FREDERICK COUNTY PLANNING COMMISSION

TITLE: Talbot Ridge Farm, Section 3, Lots 4-8

FILE NUMBER: S-1087, AP 12935 (APFO N/A, FRO 12937)

REQUEST: **Agricultural Cluster Concept Plan Approval**
The Applicant is requesting Concept Plan approval for a 5-lot Agricultural Cluster subdivision on a 250.59-acre property.

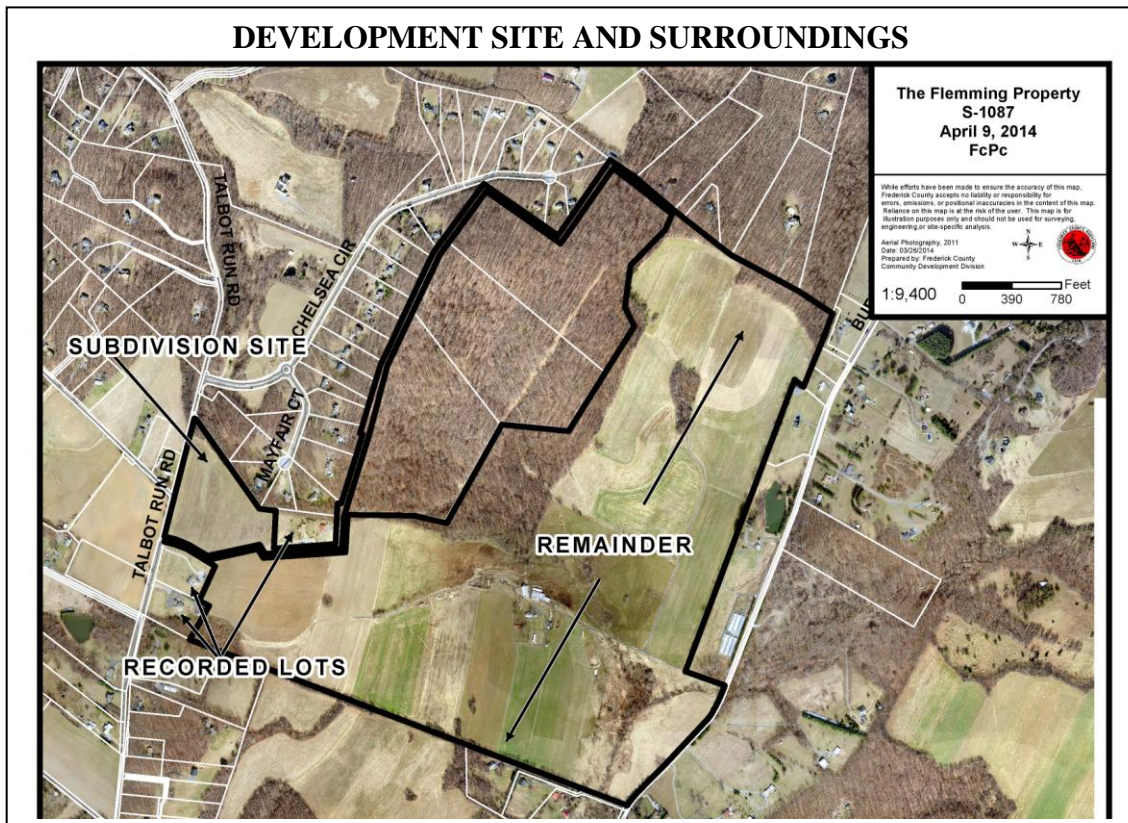
All of the proposed lots meet the minimum 40,000 sq ft lot size requirement. The proposed minimum lot width (100 feet) and yard areas (40 foot front yard, 30 foot rear yard, and 10 foot side yard) meet Agricultural District requirements in accordance with §1-19-6.100 Design Requirements of the Zoning Ordinance.

The average lot size of the 5 proposed lots is 1.25 acres, and the largest lot is 1.53 acres. However, when incorporating the 3 previously recorded lots, the project fails to meet the maximum and average lot size requirements. The 3 previously recorded lots total 9.47 acres and range between 3.00 acres and 3.47 acres in size, which exceed the maximum 2.00 acre lot size provision. The average size of all 8 lots (3 existing and 5 proposed) is 1.967 acres, which does not meet the mandatory 1.50 acre average lot size.

Proposed Lots 6 and 7 are designed as panhandle lots. A common driveway is proposed within the panhandles of these lots. The proposed common driveway will serve the panhandle lots (Lots 6 and 7) as well as Lots 5 and 8. Staff supports this panhandle design in order to facilitate the Agricultural Cluster requirements of clustering the lots and avoiding stripping the lots along the road. Note 8 on the Concept Plan states "lot owners are responsible for any common driveways serving their lots" and "the County will not be responsible for maintenance of common driveways". The Planning Commission will be required to consider a modification to allow panhandles in a major subdivision at the Preliminary Plan phase of this project.

If the Planning Commission grants the requested lot size modification and otherwise finds that the proposed subdivision meets the Ag Cluster provisions of the Zoning Ordinance, then Staff has no objection to the conditional approval of the Concept Plan.
